January 22, 2024

Re: Hamilton-Wenham Regional High School Athletic Campus Redevelopment  
Site Plan Review Application and Stormwater Management Permit Application –  
Response to Comments  
Gale JN 718601

DRAWING NO.	<b>C101</b>
10 OF 33

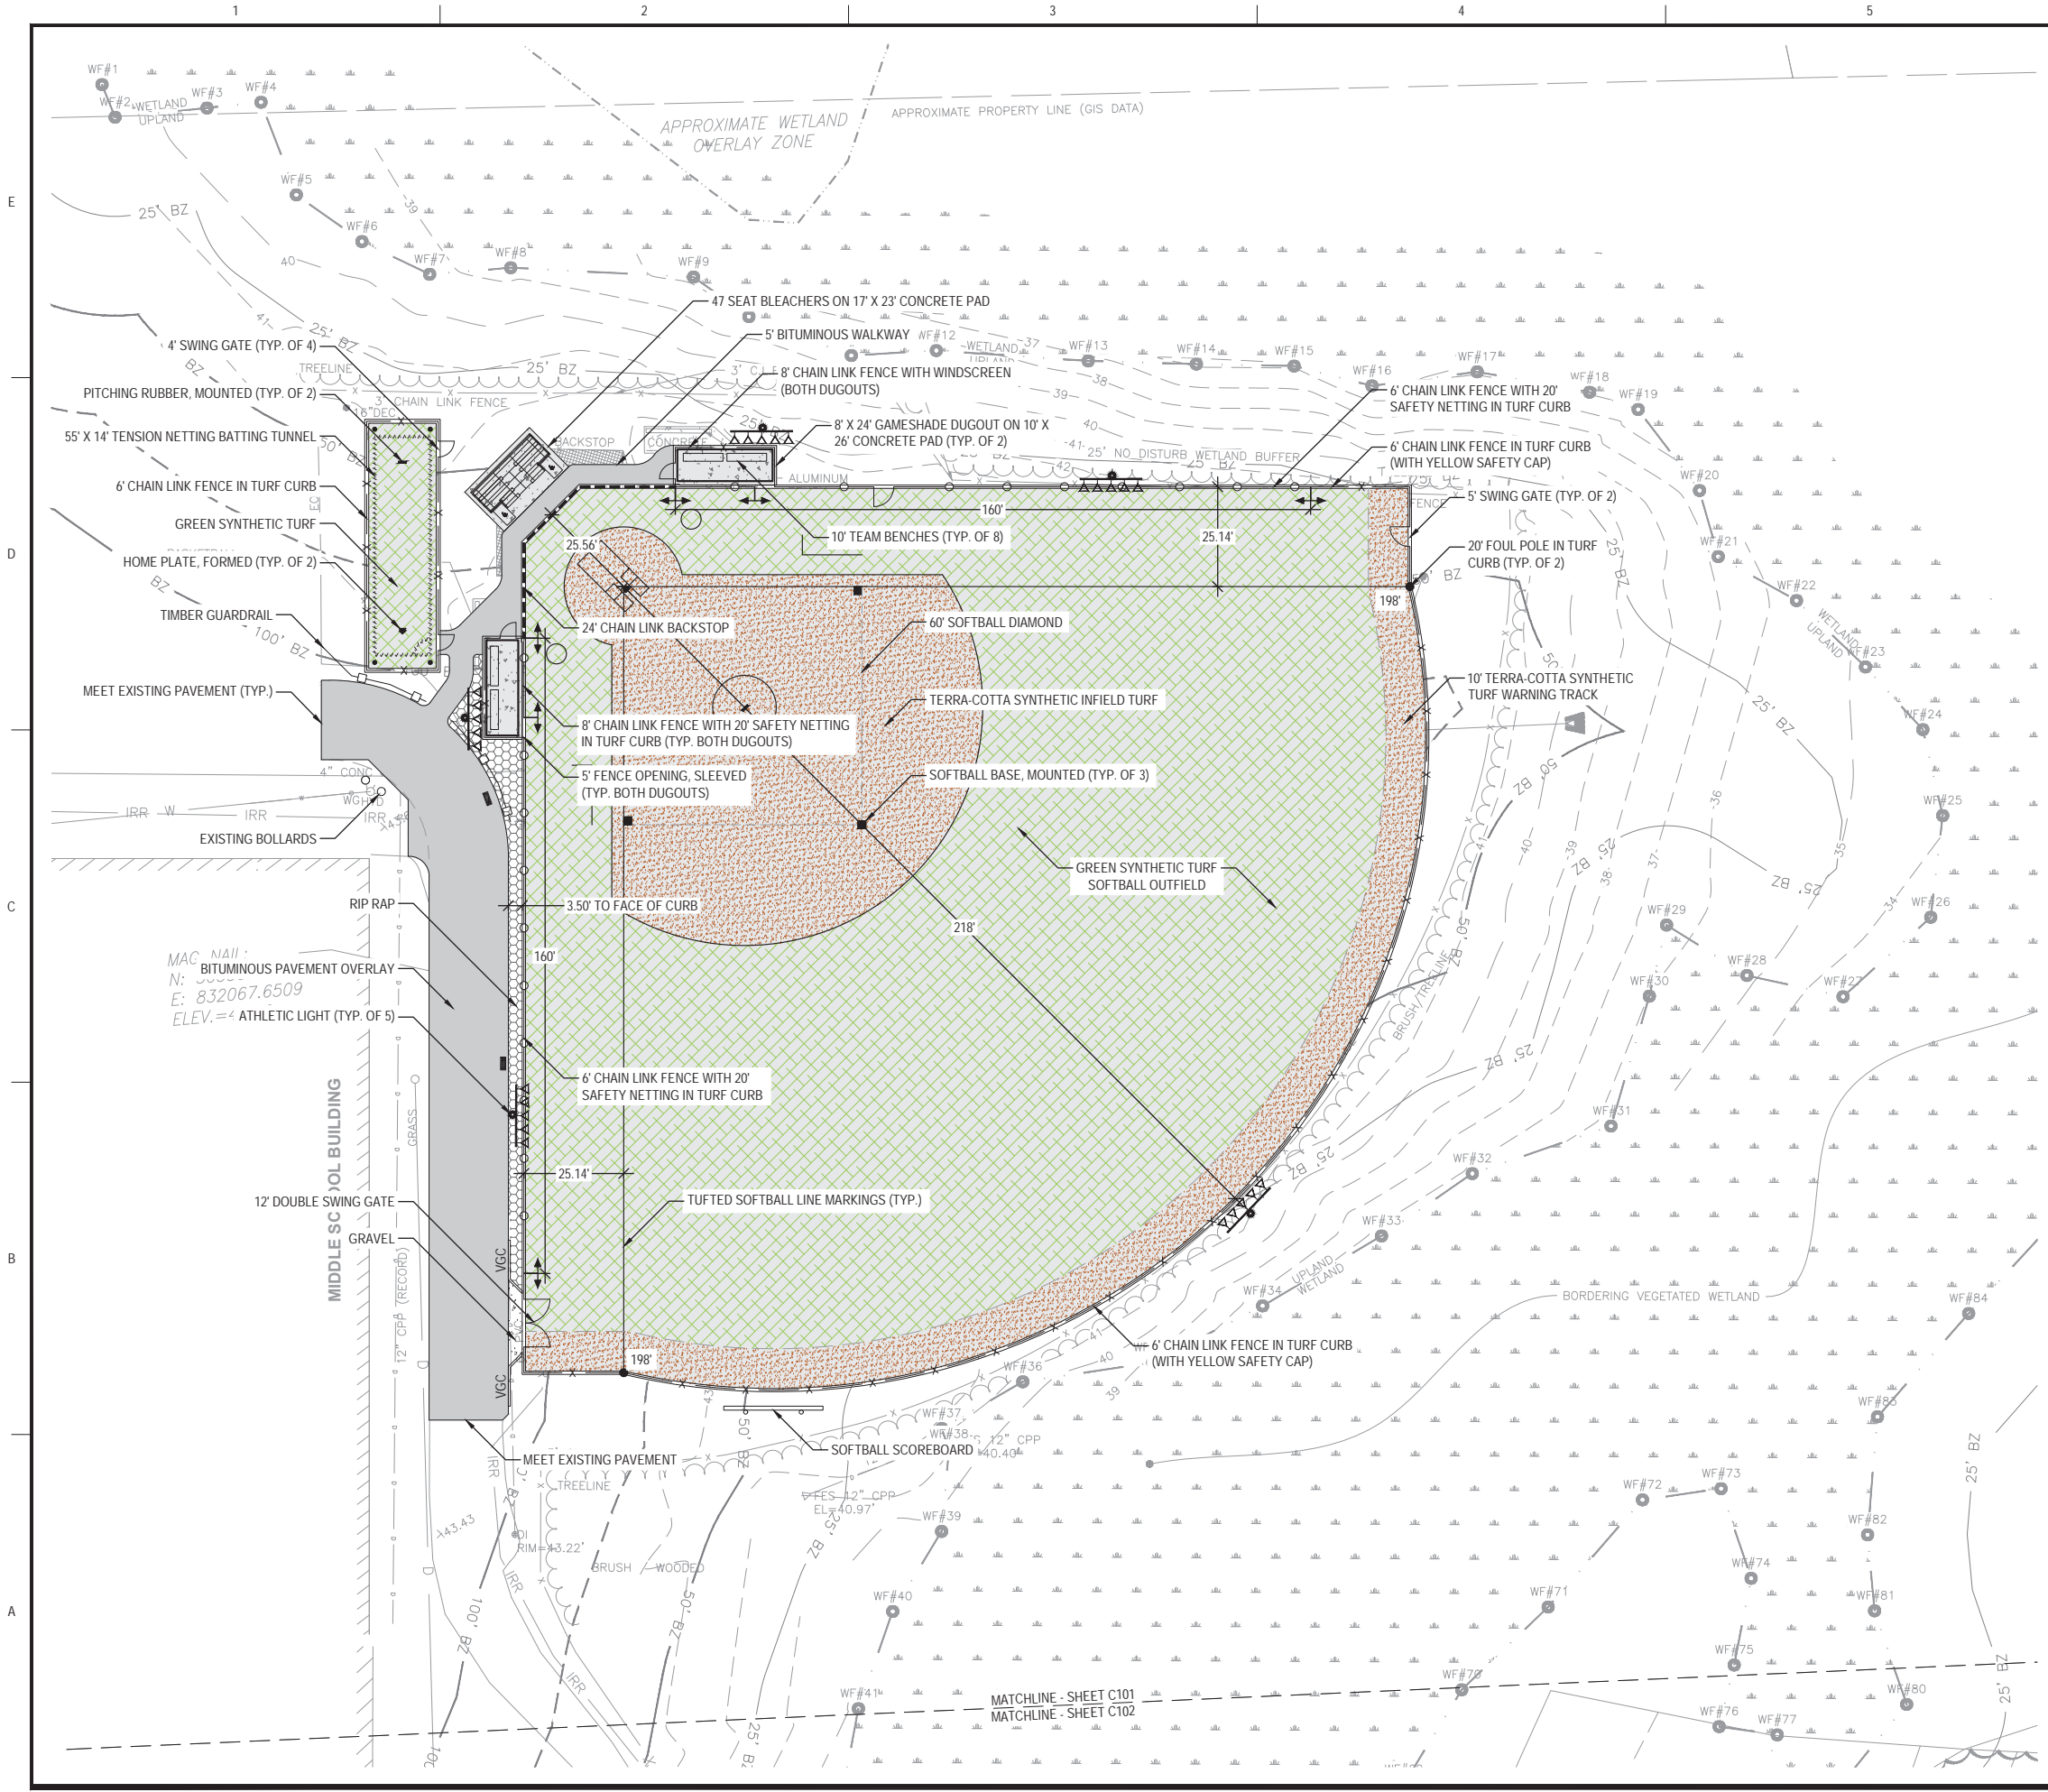
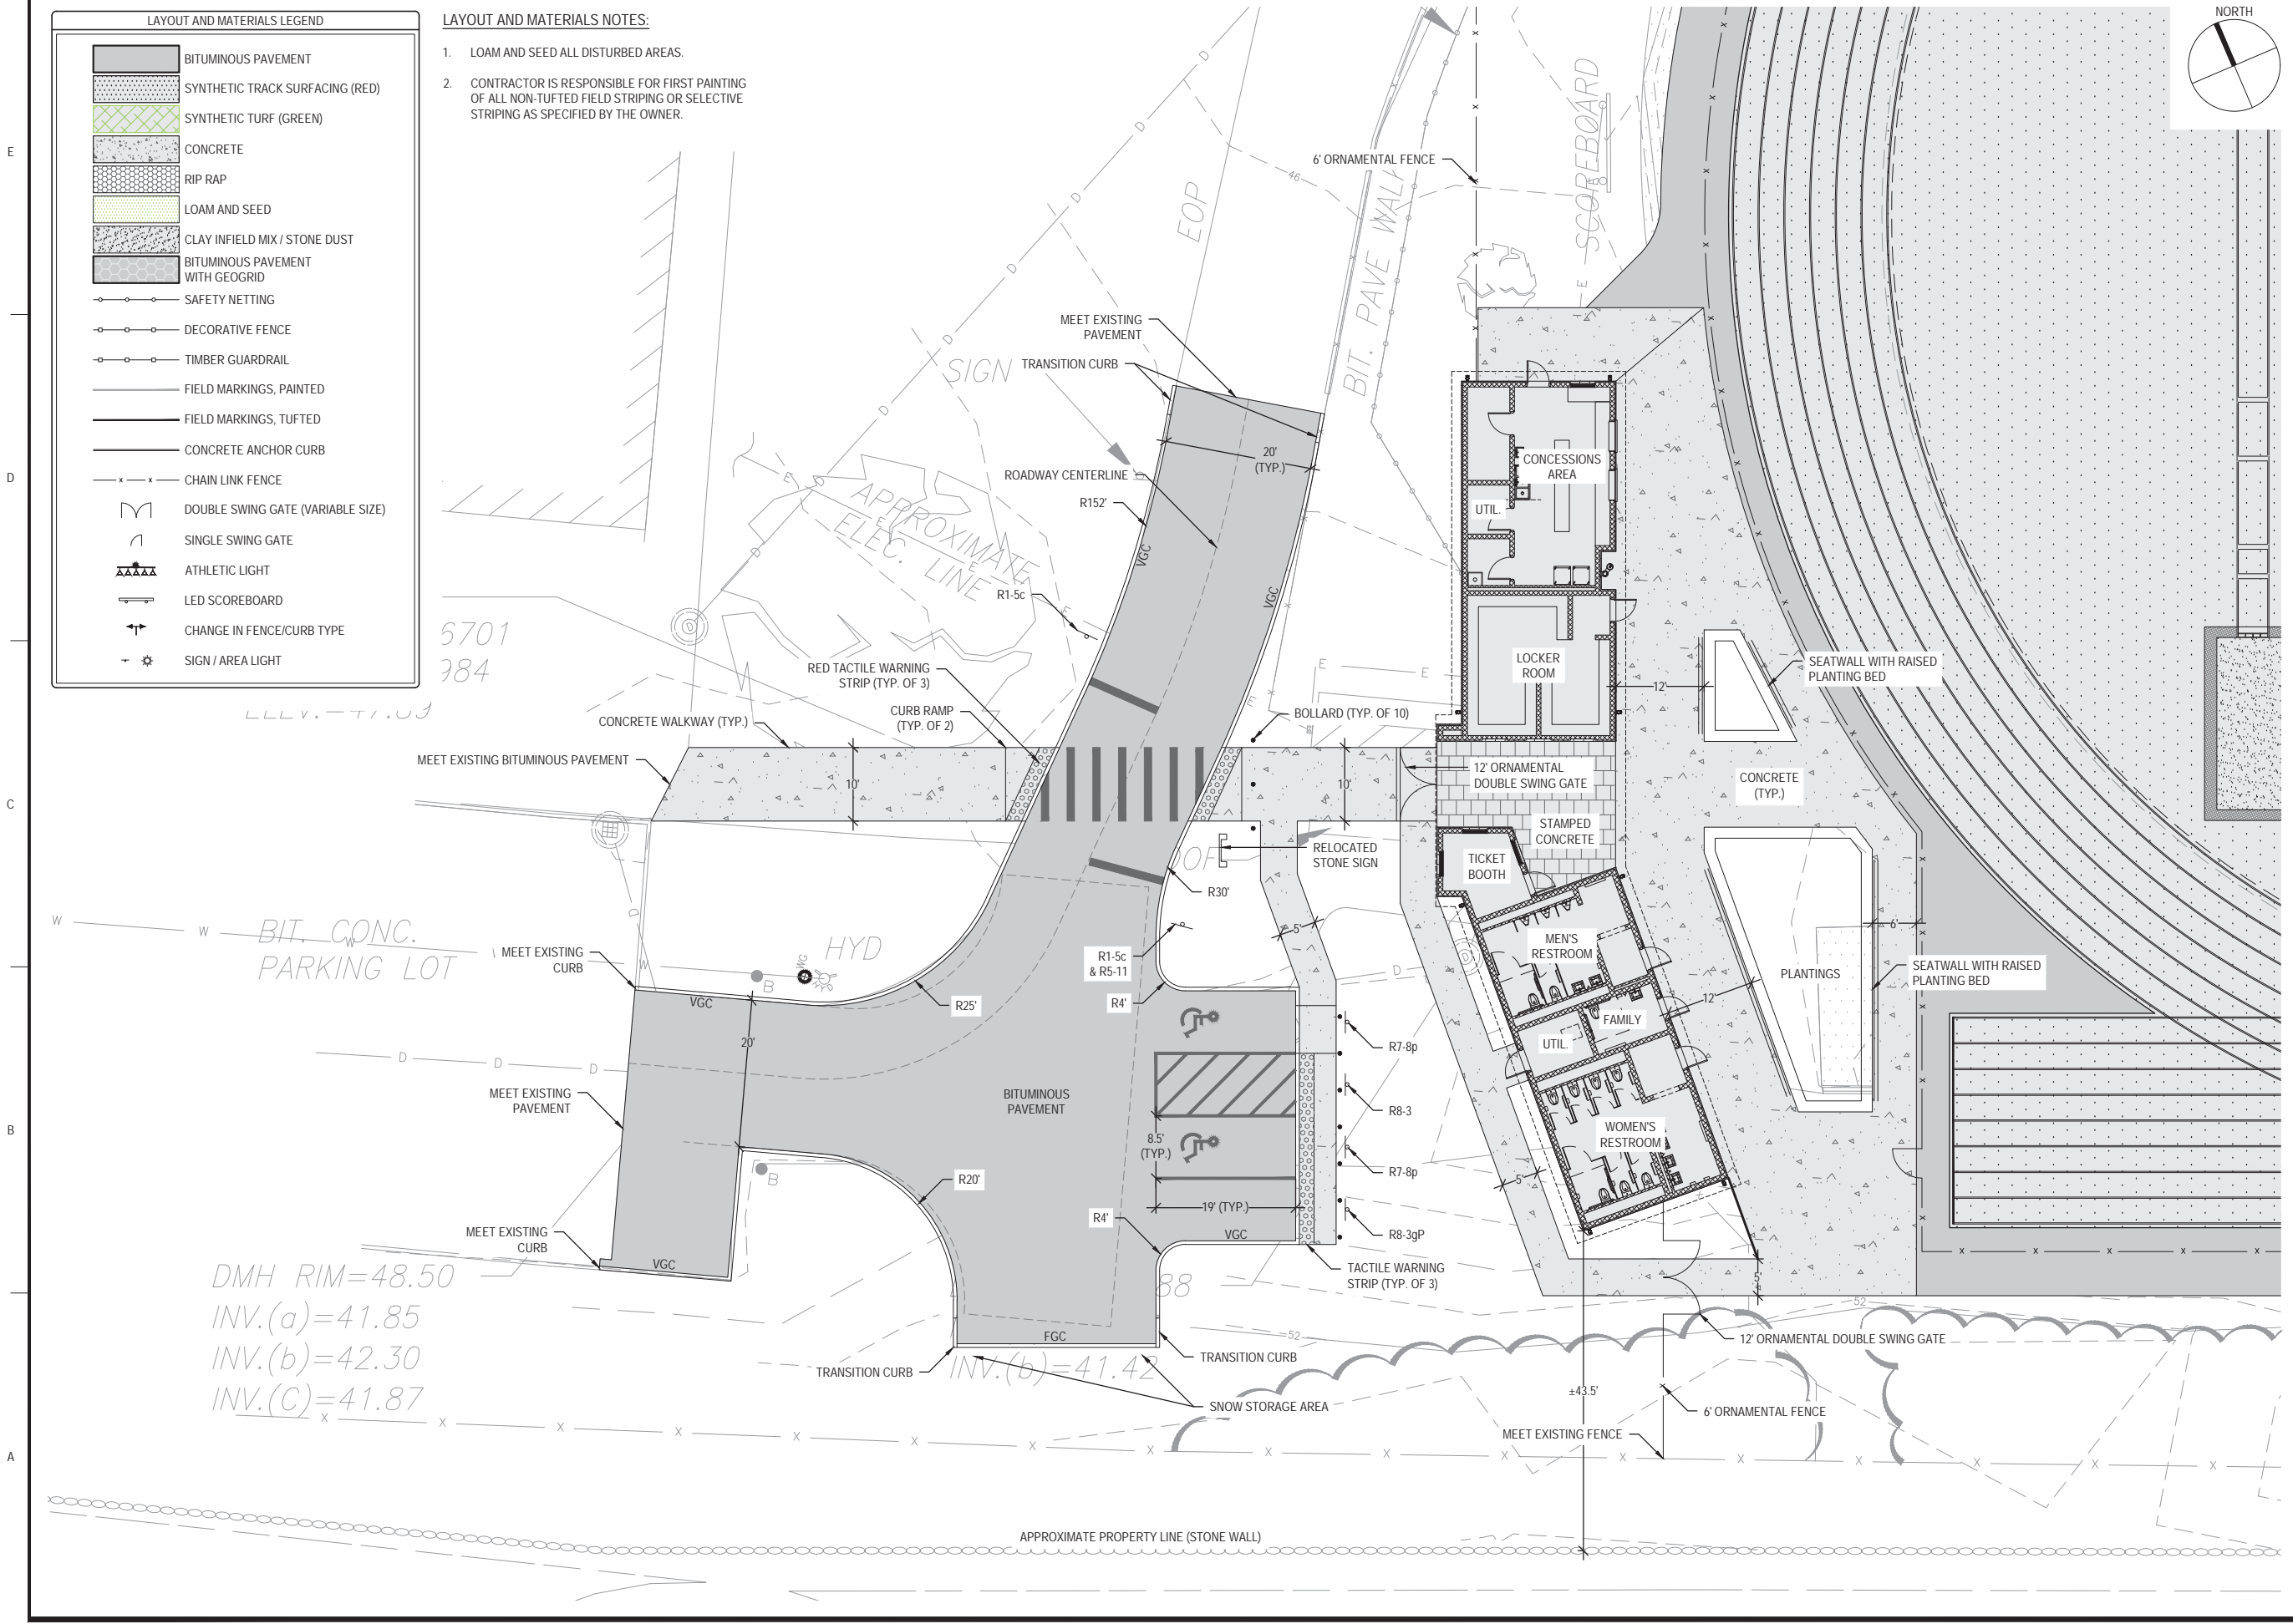
**19. Revise the geometry of the pavement approach and/or adjust the location of the 12-ft. wide swing gates serving the multipurpose field and track and the two adjacent 12-ft. wide swing gates serving the west multipurpose field and the 165 X 300 soccer field such that each field can be accessed (enter and exit) by the emergency vehicles (per Comment 12) in a single continuous turning movement. Revise the geometry of the gravel access road approach and/or adjust the location of the 12-ft. wide swing gates serving the softball field such that the field can be accessed by the emergency vehicles in a continuous turning movement.**

**20. Provide bicycle racks at each field.**

Response: The plans have been updated to adjust 12-ft. access gates, as requested, as well as providing continuous turning movements at each field. Refer to Plan Sheets C101, C102, and C103.

Response: Bike racks will be provided at each field, as requested. Refer to Plan Sheets C101, C102, and C103.
